UNITED STATES
DEPARTMENT OF THE INTERIOR
BUREAU OF LAND MANAGEMENTFORM APPROVED
OMB NO. 1004-0135
Expires: July 31, 2010**SUNDRY NOTICES AND REPORTS ON WELLS**
*Do not use this form for proposals to drill or to re-enter an abandoned well. Use form 3160-3 (APD) for such proposals.*5. Lease Serial No.
NMNM89052

☒ Oil Well ☐ Gas Well ☐ Other8. Well Name and No.
JAMES RANCH UNIT 138H2. Name of Operator
BOPCO LPContact: WHITNEY MCKEE
E-Mail: wbmckee@basspet.com9. API Well No.
30-015-397663a. Address
P.O. BOX 2760
MIDLAND, TX 797023b. Phone No. (include area code)
Ph: 432-688-224710. Field and Pool, or Exploratory
QUAHADA RIDGE;SE;DELAWARE

BOPCO, L.P. would like to change the name of the above captioned well from the James Ranch Unit #138H to James Ranch Unit D12 #138H. Per a meeting between Cody Layton, Range & Wildlife Specialist with the BLM, and BOPCO, L.P. on 8/20/13, Mr. Layton expressed the desire to adopt a standard naming convention for BOPCO, L.P.'s drilling island development. In order to accommodate Mr. Layton's request, the James Ranch Unit #138H and subsequent wells located on the James Ranch Unit Drilling Island 2, will be referred to with a nomenclature inclusive of Jam

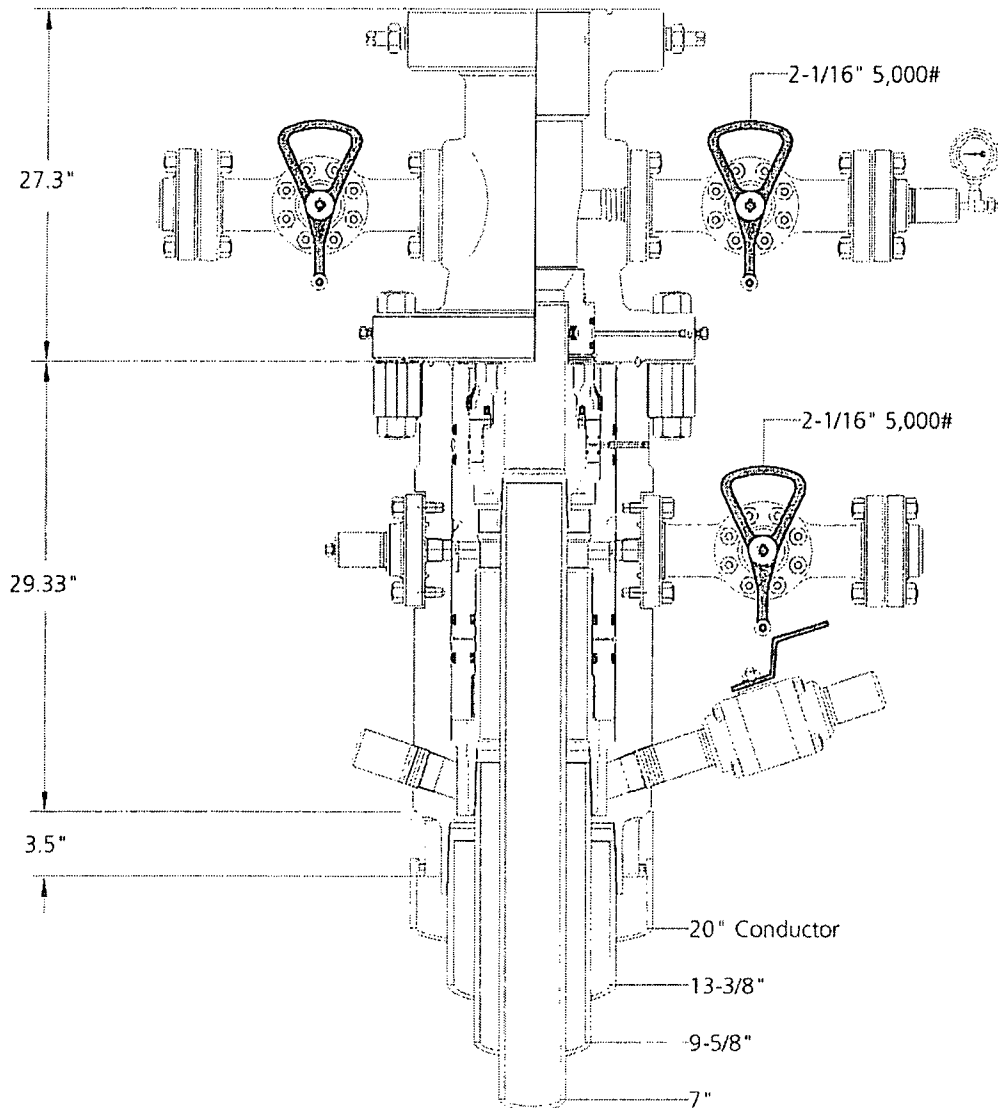
BOPCO, L.P. would like to request a change in plans for BOP testing due to the utilization of the Cameron MB-ND wellhead. We request to nipple up and test BOPE on surface casing to 3,000 psi high and 250 psi low which will cover the testing requirements for the duration of the well. Please find attached the wellhead schematic.

3. **Operator has proposed a multi-bowl wellhead assembly. This assembly will only be tested when installed on the surface casing. Minimum working pressure of the blowout preventer (BOP) and related equipment (BOPE) required for drilling below the surface casing shoe shall be 3000 (3M) psi.**

- a. Wellhead shall be installed by manufacturer's representatives, submit documentation with subsequent sundry.
 - b. If the welding is performed by a third party, the manufacturer's representative shall monitor the temperature to verify that it does not exceed the maximum temperature of the seal.

- c. Manufacturer representative shall install the test plug for the initial BOP test.
 - d. Operator shall perform the 9-5/8" and 7" casing integrity tests to 70% of the casing burst. This will test the multi-bowl seals.

Internal Hydrostatic Test Graph

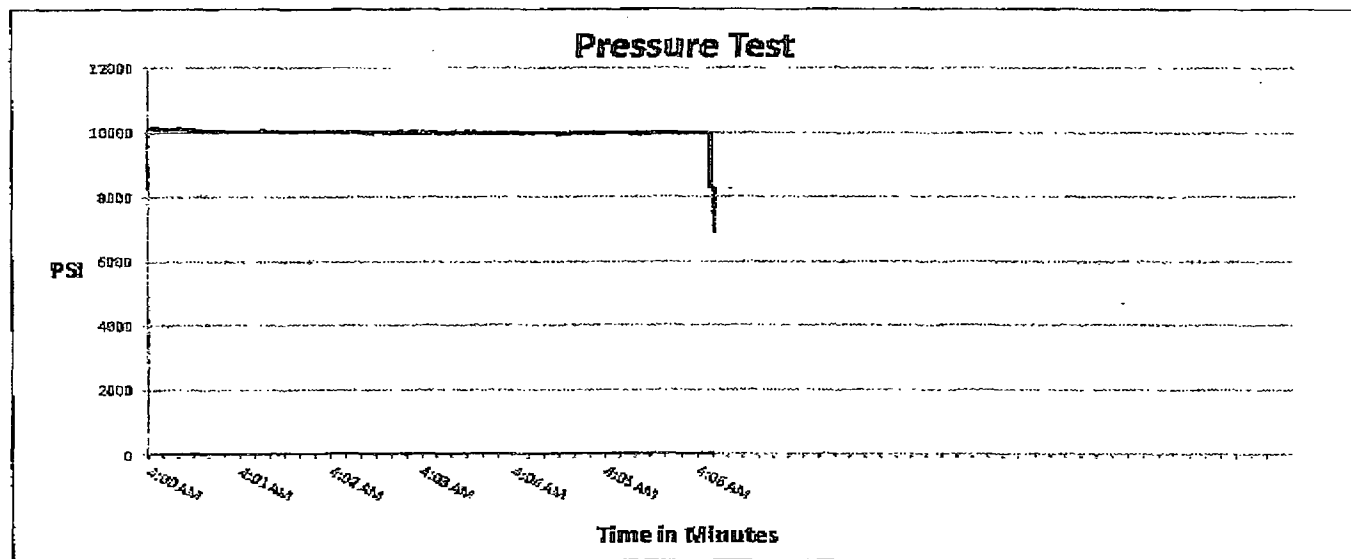
BOPCO, L.P. would like to request a variance to use an armored, 3", 5000 psi WP flex hose for the choke line in the drilling of the well if the rig is equip with hose. (See specification for hose that might be used, attached with APD exhibits). This is rig equipment and will help quicken nipple up time thus saving money without a safety problem. The hose itself is rated to 5000 psi, and has 5000 psi flanges on each end. This well is to be drilled to approximately 19,531' MD (7,306' TVD) and max surface pressure should be +/- 1,672 psi as prescribed in Onshore Order #2 shown as max BHP minus 0.22 psi/ft. Thus, 3000 psi BOPE is all that is needed for this well. Please refer to diagrams A, B, or C for choke manifold and closed loop system layout. If an armored flex hose is utilized, the company man will have all of the proper certified paper work for that hose available on location.

2. Variance approved to use flex line from BOP to choke manifold. Check condition of flexible line from BOP to choke manifold, replace if exterior is damaged or if line fails test. Line to be as straight as possible with no hard bends and is to be anchored according to Manufacturer's requirements. The flexible hose can be exchanged with a hose of equal size and equal or greater pressure rating. **Anchor requirements, specification sheet and hydrostatic pressure test certification matching the hose in service, to be onsite for review. These documents shall be posted in the company man's trailer and on the rig floor.** If the BLM inspector questions the straightness of the hose, a BLM engineer will be contacted and will review in the field or via picture supplied by inspector to determine if changes are required (operator shall expect delays if this occurs).

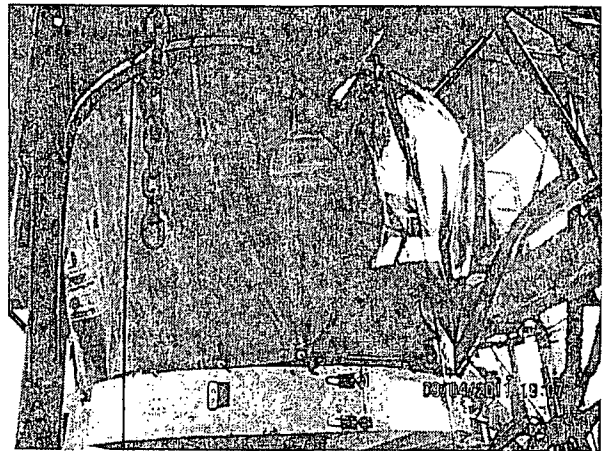
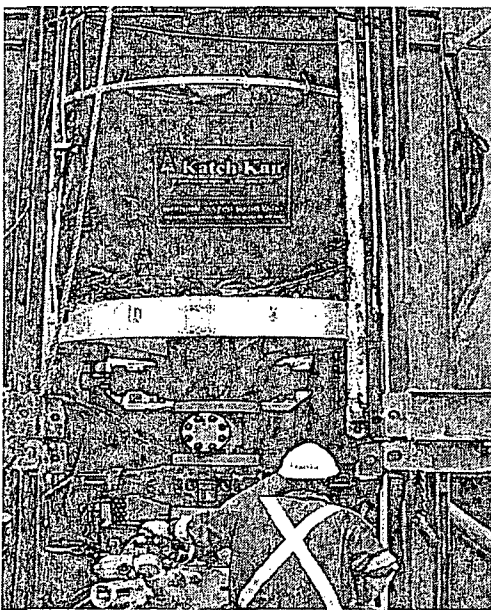
BOPCO, L.P. would like to utilize a mineral oil base synthetic mud system in the 6-1/8" hole section after drilling out the 2nd intermediate casing. We will have auxiliary equipment in place and a 24 hour mud engineer during the drilling of the lateral to minimize the risk of a mud spill. In the event of a spill while drilling, BOPCO, L.P. has a spill contingency plan as attached.

Zero Spill System Kelly Kan and Splash guard shown redirecting fluid through rotary table to be captured in Lo-Pro.

Lo-Pro with ACE mounted on BOP to collect mineral oil based mud redirected by Kelly Kan and any other that drains off rig floor.

Operator shall report any mud spill to the BLM within 12 hours of the spill.
